KEWEENAW BAY INDIAN COMMUNITY

Re: Underground Injection Control (UIC) Permit; Kennecott Eagle Mine, Marquette County, Michigan

The Community has reviewed KEMC's 2010 Design Modification and the construction drawings in KEMC's original Michigan Part 31 permit application (Figure 7-2 dated February 2006) for the TWIS (2006 Design) and strongly objects to KEMC's request to withdraw its application for a UIC permit for the TWIS. (Copies of the 2010 Design Modification drawings and the original 2006 Design drawings are attached hereto.)

TREATED WATER INFILTRATION SYSTEM DESIGN AND DETAILS

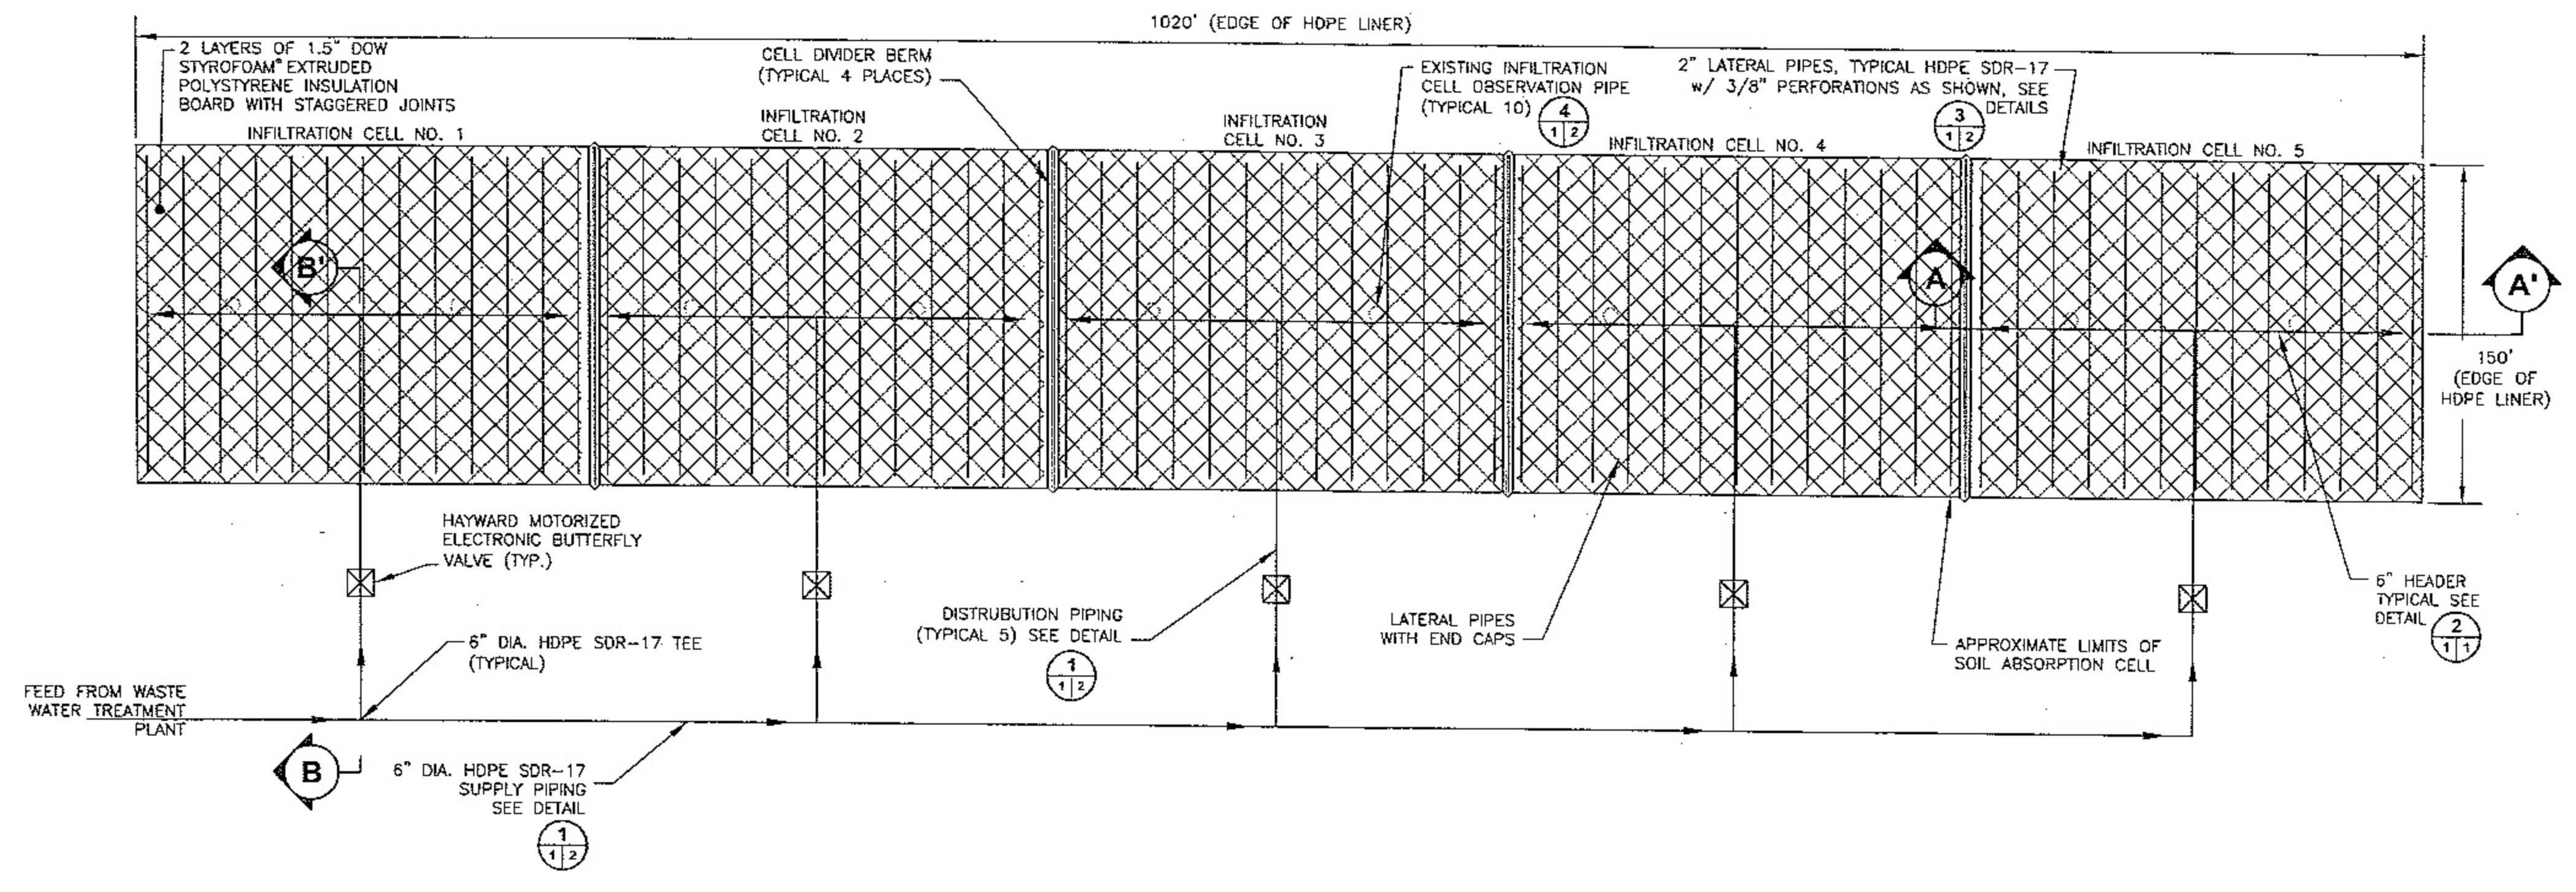
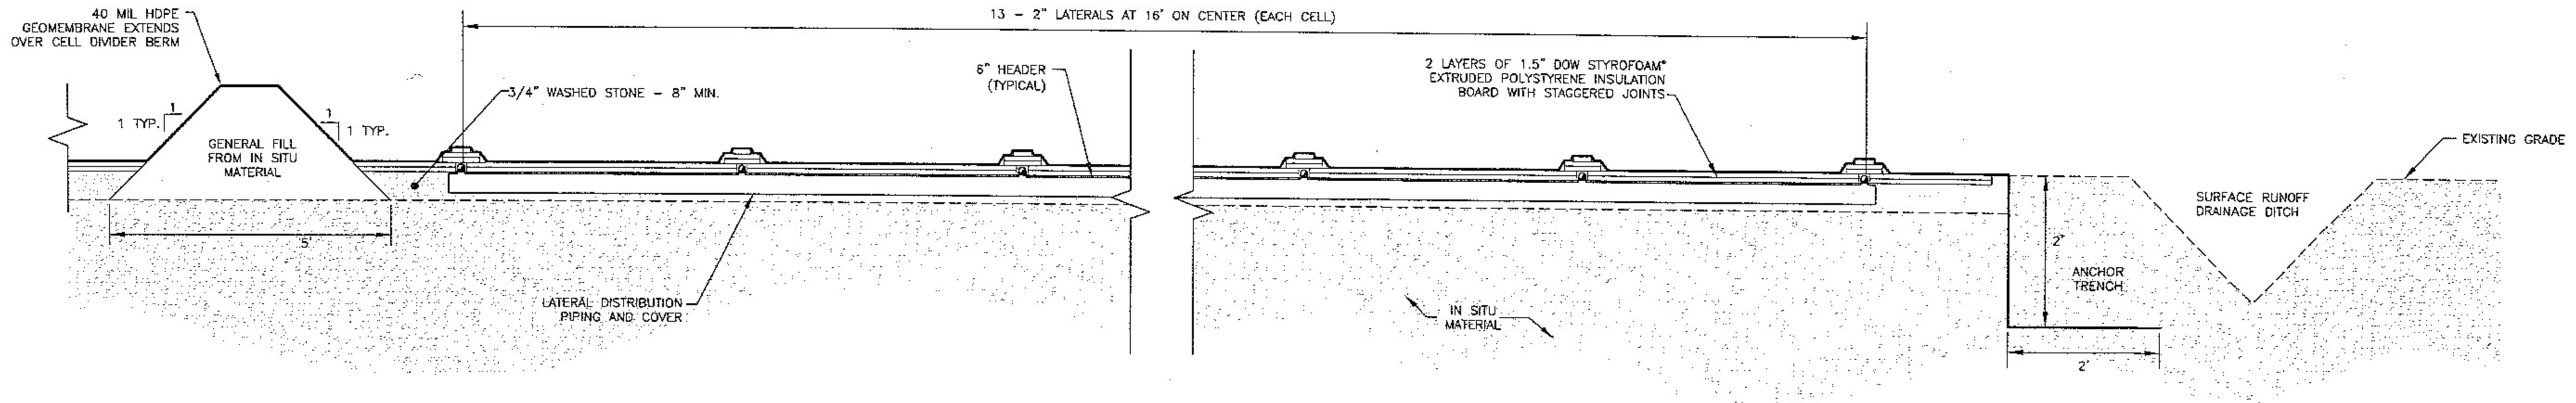
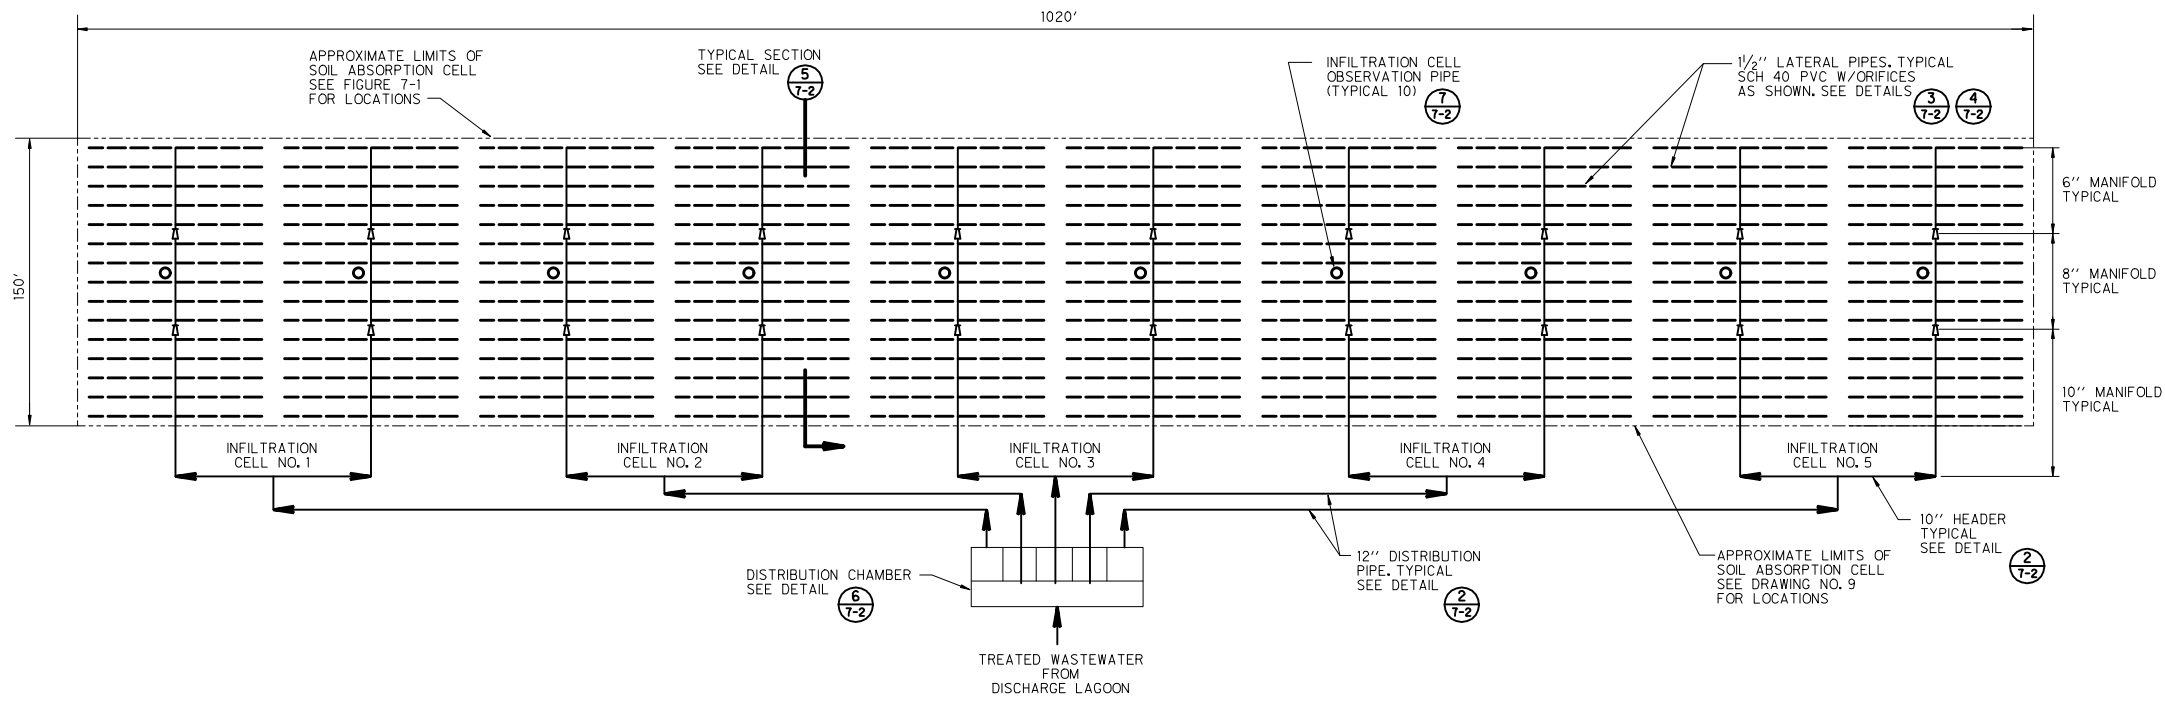
When the construction drawings for the 2006 Design are compared to the 2010 Design Modification it is clear that, **there is no change of the elevation of the piping system** – both design drawings clearly show the waste water distribution piping at the same elevation, i.e., at the existing grade. Moreover, both MDNRE and KEMC representatives have stated publicly, and repeatedly, that the actual elevation of the distribution piping is exactly the same in both the 2006 and 2010 designs. Besides minor changes in pipe size and washed stone thickness, the only substantive change in the 2010 Design Modification from that depicted in the 2006 Design is that the piping system would be covered, for purposes of insulation from freezing conditions, by Styrofoam insulation instead of insulation by a man made mound of soil.

The UIC definition of “subsurface fluid distribution system”, which is “an assemblage of perforated pipes, drain tiles, or other similar mechanisms **intended** to distribute fluids below the surface of the ground” is exactly what is depicted in KEMC’s 2010 Design Modification and the 2006 Design. Based on the UIC definition of “well injection” by use of a “subsurface fluid distribution system”, the pertinent concept or trigger for a UIC permit requirement is the “intent” of the system to “distribute fluids below the subsurface of the ground”. Moreover, the definition does not require that the “system” of perforated pipes, etc., be located underground. It should be noted, as discussed above, the original TWIS system of “perforated pipes” which prompted the EPA Call – In Notification (March 22, 2007) was at existing grade and not underground, and was located at exactly the same elevation (at grade) as specified for the “perforated pipes” in the 2010 Design Modification

The 2010 Design Modification **substitution** of a Styrofoam insulation system for a man made mound of soil insulation system for the piping of the subsurface fluid distribution system, as specified in the 2006 Design, does not change or have any effect on the volume or industrial nature of mine waste water that will be discharged by KEMC's assemblage of perforated pipes which is **intended** to distribute fluids below the surface of the ground and ultimately to an underground source of drinking water.
